CITY OF NOVI CITY COUNCIL
FEBRUARY 5, 2023

SUBJECT: Initial consideration of Planned Rezoning Overlay (PRO) eligibility of the request of Sakura Novi Residential, LLC, for Sakura East JZ23-41, to rezone from Light Industrial (I-1) to Town Center One (TC-1) on land located on the south side of Eleven Mile Road, west of Meadowbrook Road in Section 23. The applicant is proposing to utilize the Planned Rezoning Overlay option to rezone and develop a 45-unit multiple-family townhome development on approximately 3.5 acres of land. Under the PRO Ordinance, this initial review by City Council is an opportunity to review and comment on the eligibility of the proposal and give feedback to the applicant before they formalize their plans.

Re: Sakura East PRO Concept Plan Review Response Letter – **Updated to address Planning Commission comments**

sheet title:
Tree Preservation Plan

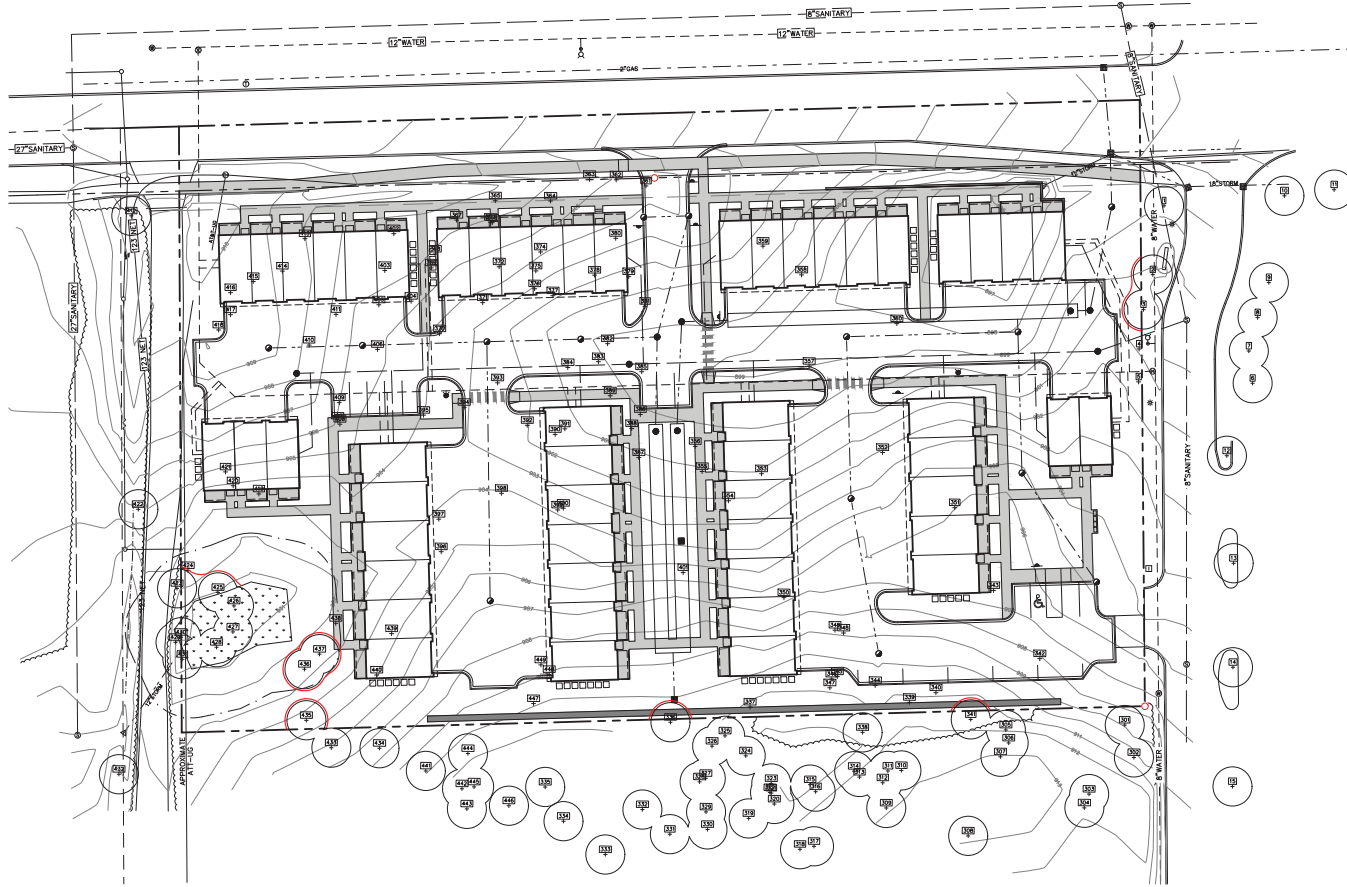
The Plan and Report depict one wetland onsite that is 0.03 acres. MSG visited the Site on November 6, 2023 to evaluate the wetland limit lines depicted on the Sheet L-3 of the Plan. The observed conditions at the project site generally consisted of vacant, mostly wooded land. Wetland delineation markers (labeled pink ribbon) were observed that generally corresponded to the perimeter of Wetland 1. Wetland 1 was observed to be forested wetland. **MSG does not agree with the delineation of Wetlands 1 as depicted on the Plan and flagged in the field. Based on MSG's assessment of Site conditions, the boundaries of Wetland 1 should be extended up to the off-Site access road and include trees 423, 424, 436, and 437.**

Figure 1: Current Zoning

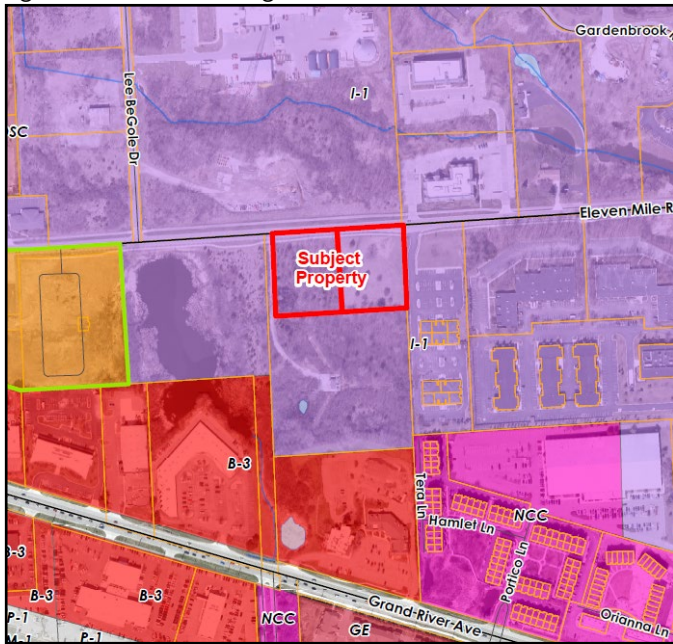
To the **east** is an area zoned I-1 Light Industrial. There is an office complex there with two existing buildings, with a third building approved to be constructed. There is no firm timeline on when that building would be constructed. This area is planned to remain Light Industrial use in the City's Master Plan. If residential uses are located adjacent to the property, the uses permitted in the I-1 district would be severely restricted compared to the list of uses that could otherwise be permitted. In addition, there is no berm separating the properties, as is required when non-residential uses are adjacent to residential uses. It would be the applicant's responsibility to provide the required berm and screening on the parcel to be developed with residential uses. No such berm is currently proposed

The proposed residential use would be surrounded on all sides by industrially zoned properties. There is no obvious connection to the larger Sakura Novi development, except for the sidewalk along 11 Mile Road and identical townhouse product type to be developed. The lack of contiguity between the projects is a significant barrier to justifying the proposed rezoning. Another barrier could be the completion of the planned road extension of Lee BeGole Drive down to Grand River, which preliminary designs have shown to be located just west of the subject property. In addition,

Photo 1: View of buckthorn scrub/shrub understory, facing east.

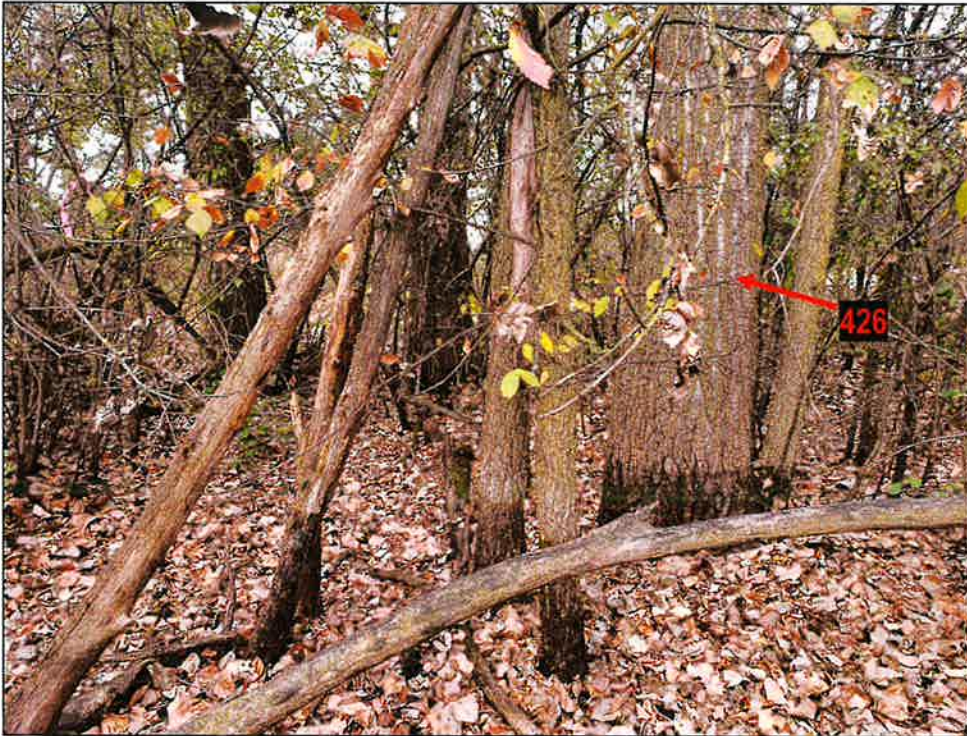
The City of Novi Regulated Woodland Map indicates the property does not include a City-regulated woodland (Figure 1). Based on MSG's review of the arborist survey performed by Land Design Studio (Plan Sheets: L-3 "Tree Preservation Plan" and L-4 "Tree Survey") and a site visit performed by a MSG on November 6, 2023, MSG has determined this site should not be considered a City-regulated woodland. The parcel is mostly wooded; however, it is a very low quality forest. The site is almost completely dominated by buckthorn, a highly invasive tree species, with only a few quality trees interspersed at a low density, including sugar maple, crab apple, and little leaf linden. Site photos are included in this letter.
